## Committee of Experts on the Transport of Dangerous Goods and on the Globally Harmonized System of Classification and Labelling of Chemicals

### Labelling of sets or kits: Comments on document ST/SG/AC.10/C.4/2017/5

Transmitted by the expert from the United States of America

##### Inner container label

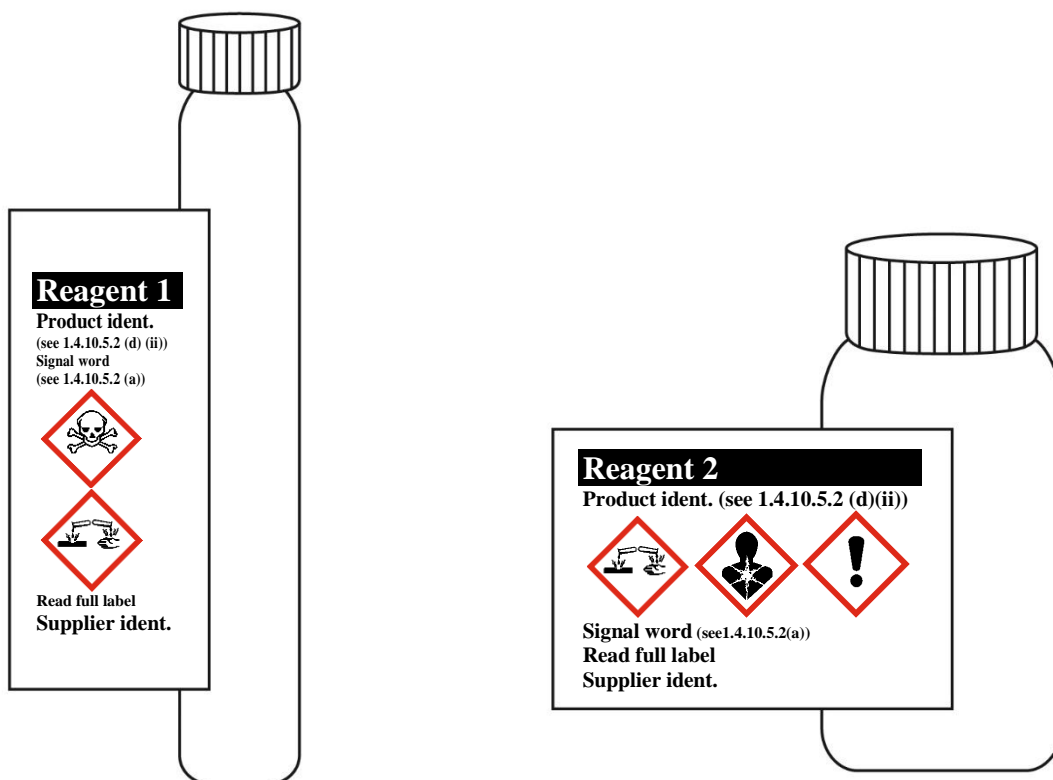
**Comment:** Recommend putting the company name and phone number on the label below similar to other small packages examples
